Minutes of the Reorganization Meeting of the Haverford Township Planning Commission held on Thursday, January 9, 2020 at 7:00 p.m. in the Commissioners' Meeting Room, 1014 Darby Road, Havertown, Pa. 19083.

Item # 1 Sleepy Valley Holdings, LLC. Greenbriar Lane –DC Folio No. 22-09-01348-00 Review of preliminary/final minor subdivision plan

Preliminary/Final Minor Subdivision Plan 1613 Pelham Avenue- D.C. Folio No. 22-06-01738-00

APRIL 3, 2020 1" = 40' 2020-153-1932 PROJECT NUMBER: 20-009

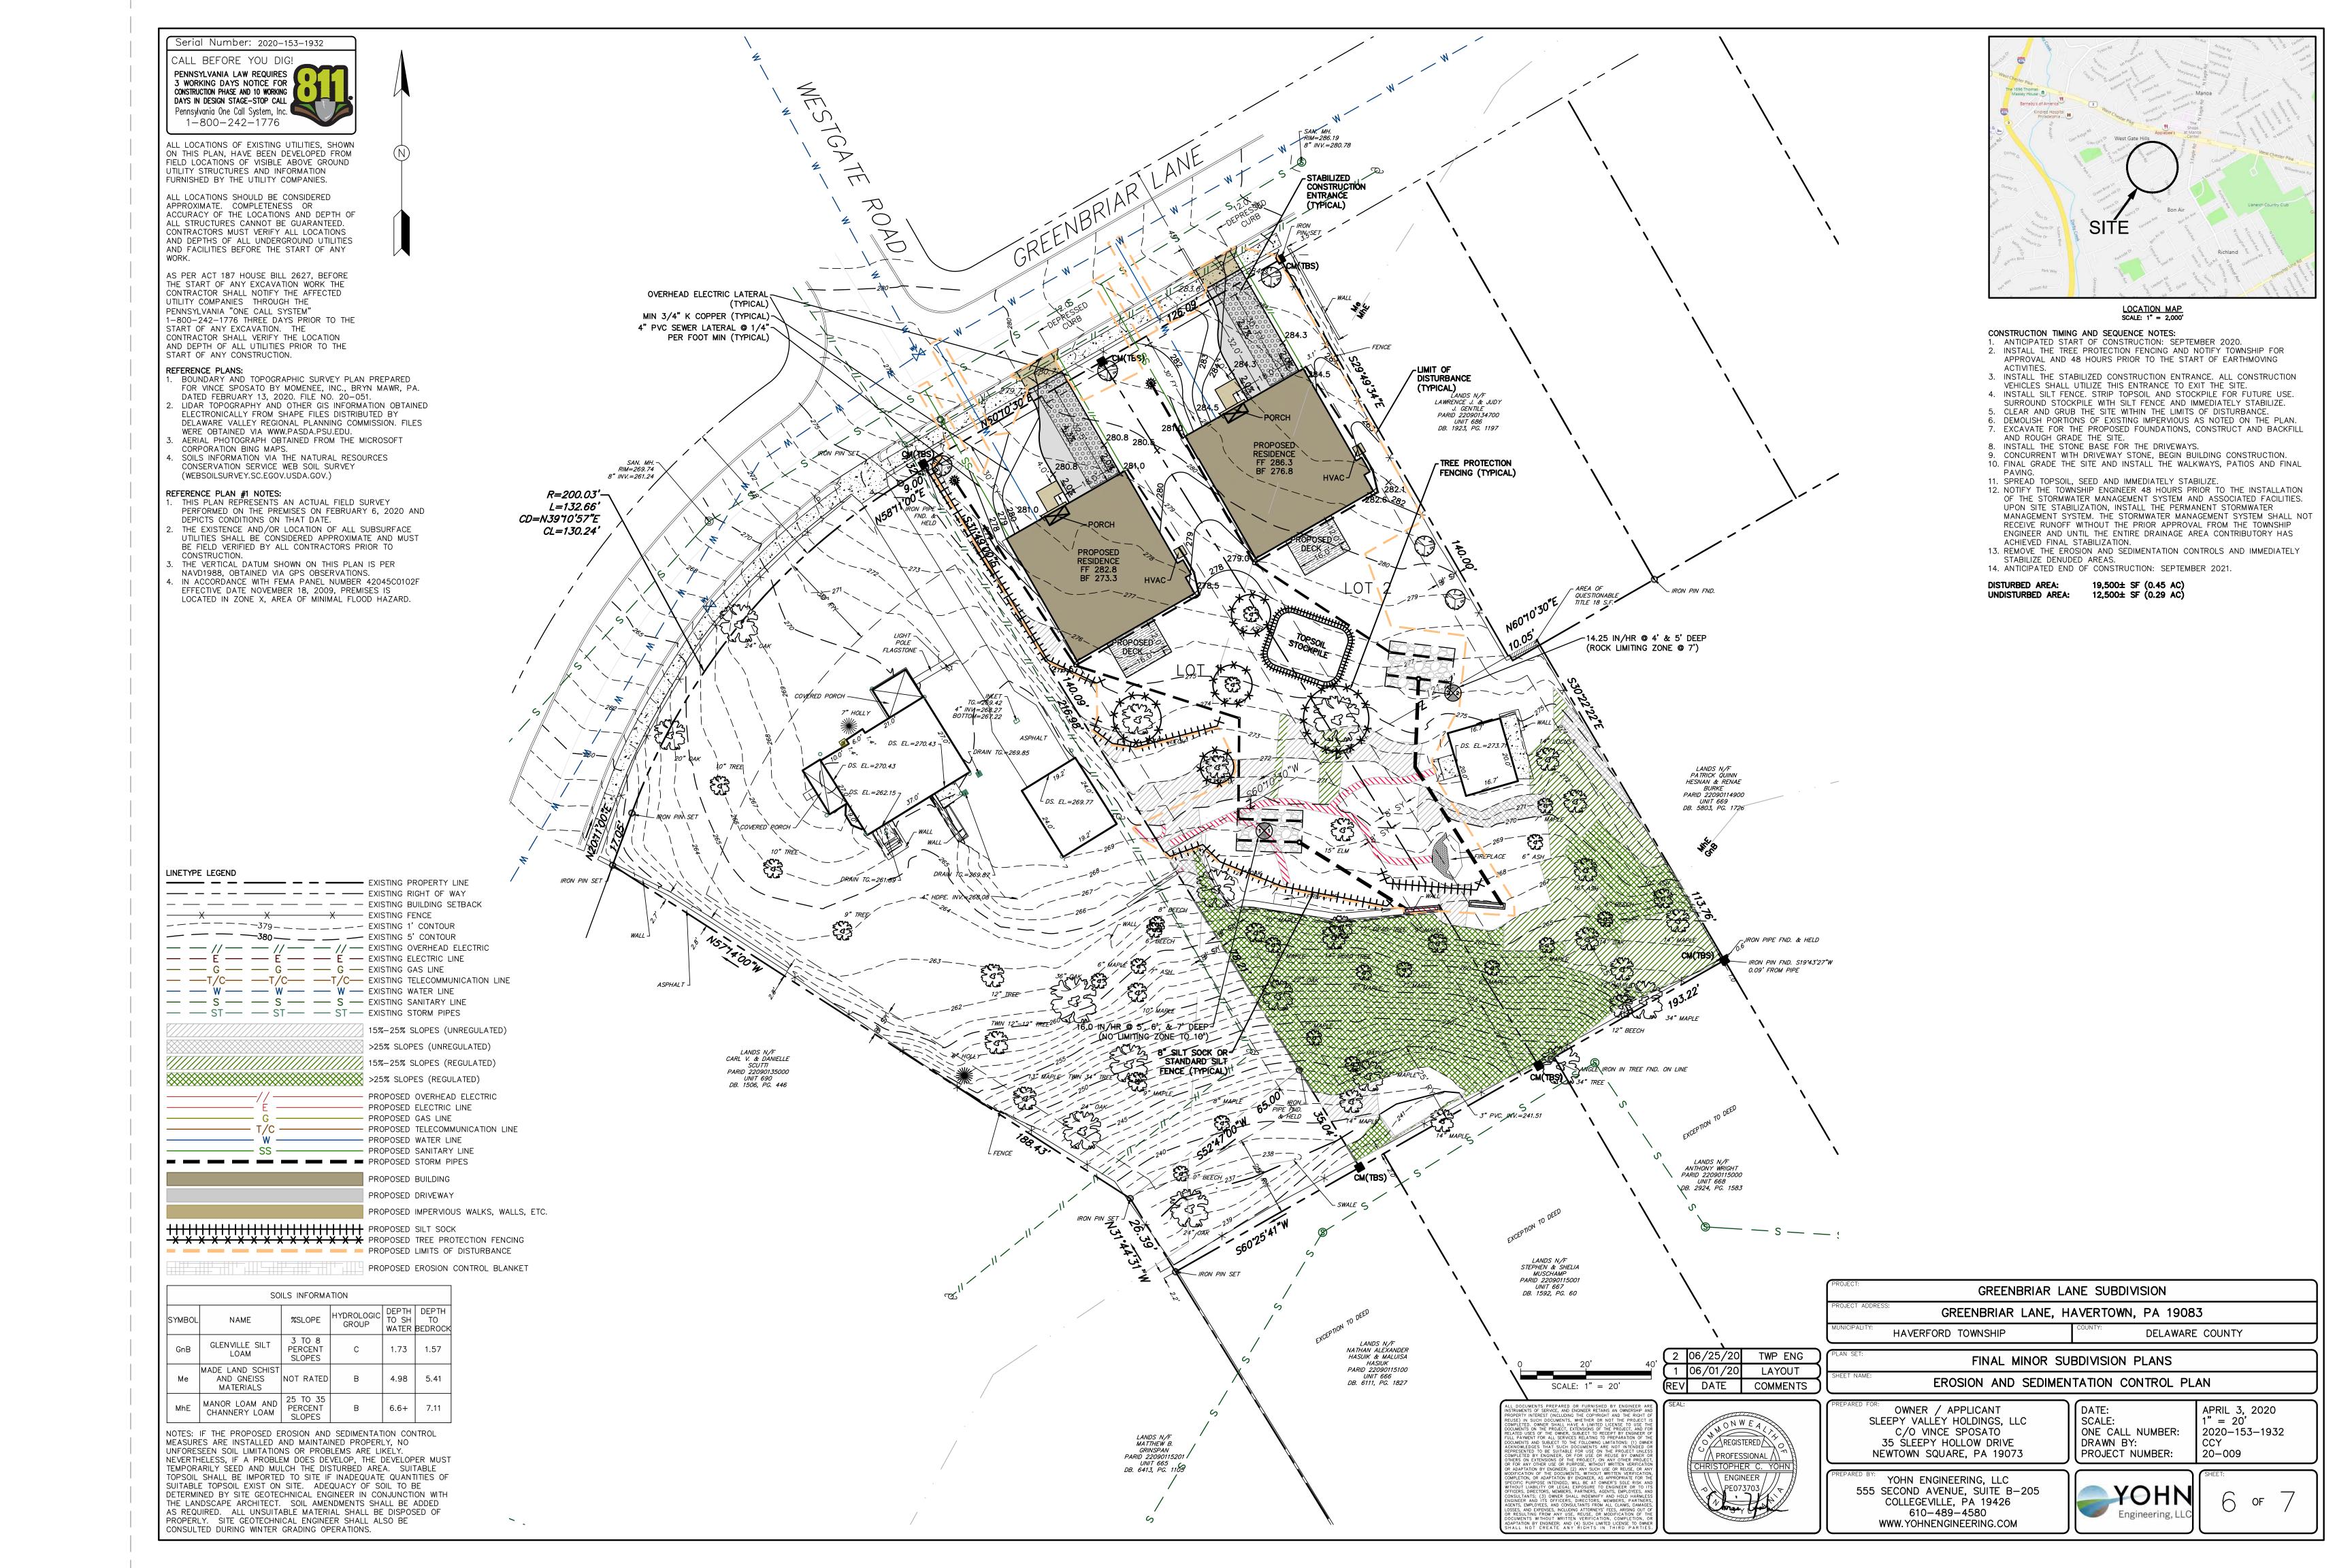
Mr. Yohn begins with a description of the plan with plan sheet 1 showing the existing house and the vacant parcel to be divided into two new lots. They do meet the code requirements for lot area and minimum lot width and will meet the other requirements for setbacks and impervious coverage.

Item #9 Review with Mr. Faulkner indicated the need for more information is needed to show which steep slopes are regulated and those which are not.

Mr. Capuzzi suggested no action to be taken with this plan until a comfort level is reached with a storm water system. Mr. Yohn proceeded with a review of the illustrative site plan, vicinity site plan and the grading plan for the two new homes. These plans indicate placement and setbacks of the residences and high point for water runoff. Lot 2 has a swale and lot 1 to drains including rainwater conductors.

Mr. Capuzzi noted the grading plan appears to remove at least 6 large trees to accommodate construction and the Township has requirements to replace trees. The proposed landscaping and tree replacement details are normally reviewed by The Shade Tree Commission. This review is needed before recommendation of final approval for the subdivision plans may be made.

- 5. The plans have been revised to include proposed building, driveway, walkway, etc. locations as shown on sheet 1.
- 6. The plans have been revised to show additional right of way and a partial waiver request as shown on sheet 2.
- 7. The Applicant will work with the surveyor to resolve the area of questionable title prior to recording. In order to be more conservative, the area of questionable title has been removed from the calculations as shown on sheet 2.
- 8. The plans have been revised to include the required verbiage as shown on sheet 2.

- 9. The plans have been revised to show steep slopes meeting the township definition and those not meeting the definition as shown on sheet 3; however, we will continue to work with the Township Engineer to confirm compliance.
- 10. The plans have been revised to show the portions of walls that crossed property lines to be removed as shown on sheet 3.
- 11. The plans have been revised to include Construction Note #21 as shown on sheet 5.

- The spreader on Lot 2 was adjusted to be located as far west as possible in order to direct overflow runoff to the existing swale on the southern side of Lot 1 as shown on sheet 4.
- The Applicant discussed hazardous trees with the adjacent property owner and obtained a report from an Arborist indicating which trees are scheduled to be removed. The report was forwarded to the Shade Tree Commission and the tree replacement calculations have been revised and replacement trees are now shown on the plan as shown on sheet 4.
